CB/RL/P6359  
28<sup>th</sup> July 2017

**The Coach House 50A Belsize Square London NW3 4HN**  
**Letter of Objection against Planning Application ref. 2017/3348/P**

**EXISTING PHOTOGRAPH 2 – FLANK ELEVATION OF 50 BELSIZE SQUARE (SHOWING  
IMPACT AND PROXIMITY OF WINDOWS INLIGHT OF PROPOSED WORKS)**

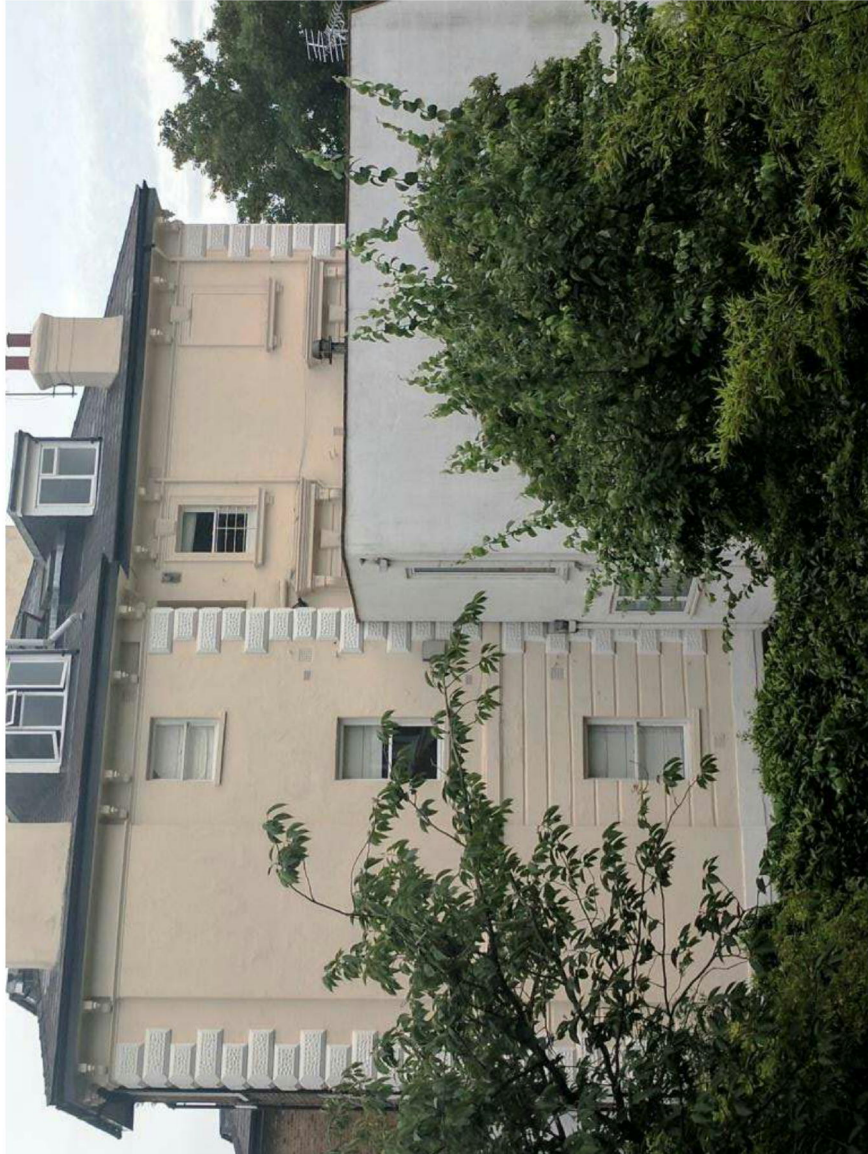
Extensive floor-to-ceiling glazing is proposed for all rear windows which fail to take account of existing windows on the flank wall of No 50. The proposed windows will increase overlooking between these habitable rooms and will be further exacerbated by the rear extension which will position the proposed windows immediately adjacent to the existing flank wall windows of No. 50.

In light of the above, please refer to the enclosed photos which demonstrate the existing close proximity of 50A Belsize Square and the flank elevation at 50 Belsize Square.
